To: T10 Technical Committee
From: Rob Elliott, HP (elliott@hp.com)
and Mallikarjun Chadalapaka (cbm@rose.hp.com)
Date: 14 July 2002
Subject: T10/02-232r1 SAM-2 SPC-3 SBC-2 SSC-2 Clearing effects of I_T nexus loss

Figure 1. Power on, hard reset, logical unit, and I_T nexus loss relationships

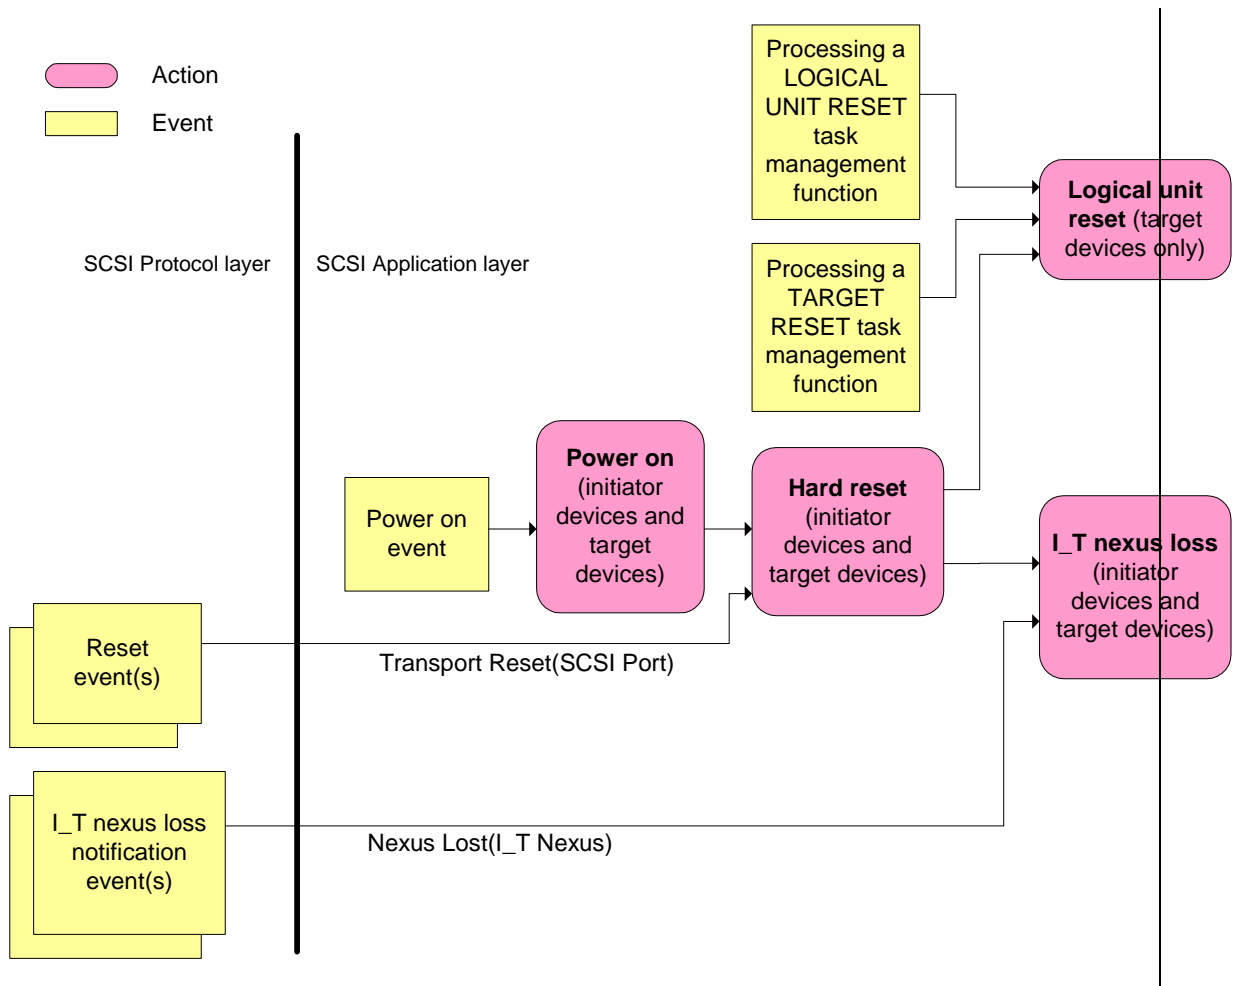
Figure 1 shows the relationships between power on, hard reset, logical unit reset, I_T nexus loss, and their associated events.

Table xx shows the additional sense code that shall be used when a unit attention is reported for each of these actions by a logical unit. The protocol may define a more specific additional sense code for reset events than SCSI BUS RESET OCCURRED (e.g., TRANSCEIVER MODE CHANGED TO LVD). The actions are sorted from least-specific to most-specific. The most-specific action known to the logical unit shall be reported.
